# STERLING RANCH SKETCH PLAN AMENDMENT

### SKETCH PLAN AMENDMENT

SKP-22-004

# Sketch Plan Drawing(s)\_v1.pdf Markup Summary 8-15-2022

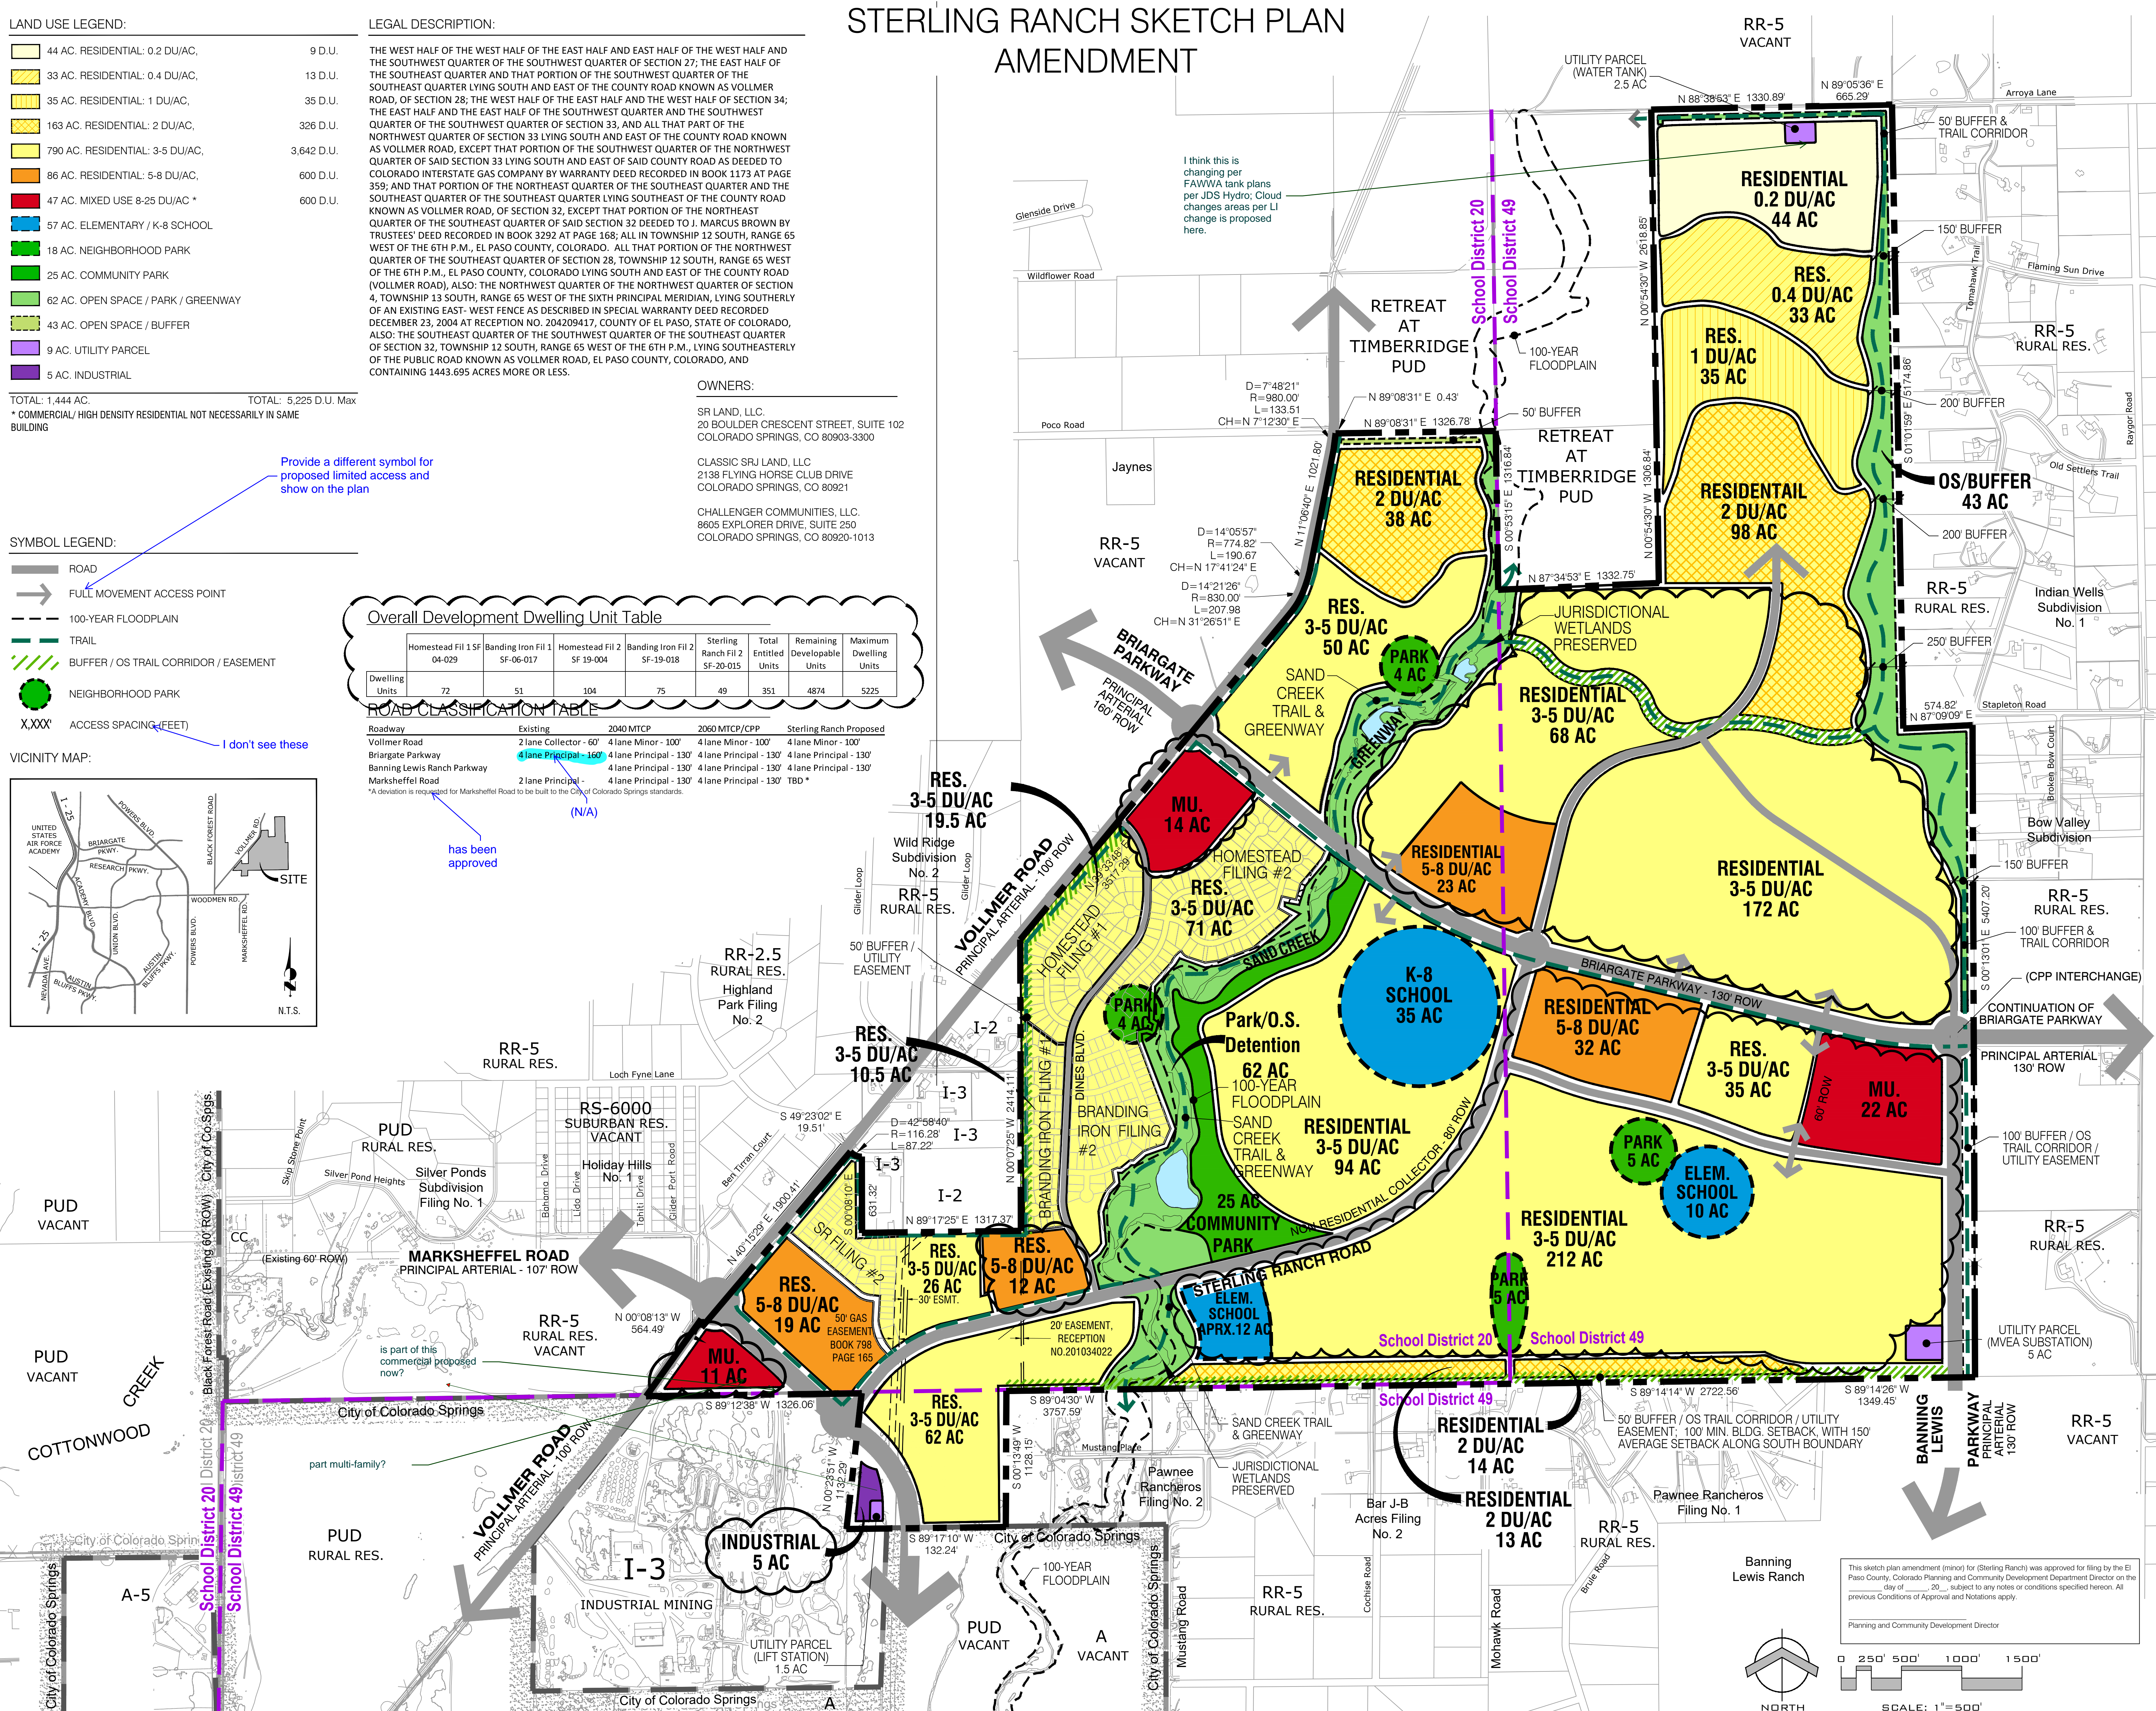
Provide a different symbol for proposed limited access and show on the plan

I don't see these

is part of this commercial proposed now?

part multi-family?

I think this is changing per FAWWA tank plans per JDS Hydro; Cloud changes areas per LI change is proposed here.
